Access Compliance Report Public Rights-of-Way (Curb Ramps)

Main Street: EMBARCADERO_PL		Cross Street: DANA_POINT_HARBOR_DR		Location:	SW
ADA ID: RPRK220208155140	Ramp Type:Type 1 - Perpendicular	Initial Pass/Fail: Fail	Overall Compliance: No	Severity Score:	16

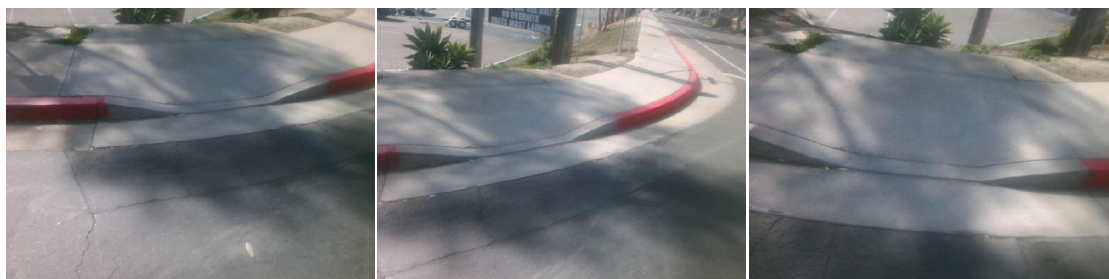
R204.3, R304.2.2, R304.5.3, STD 1115

Remove & Replace Entire Ramp.
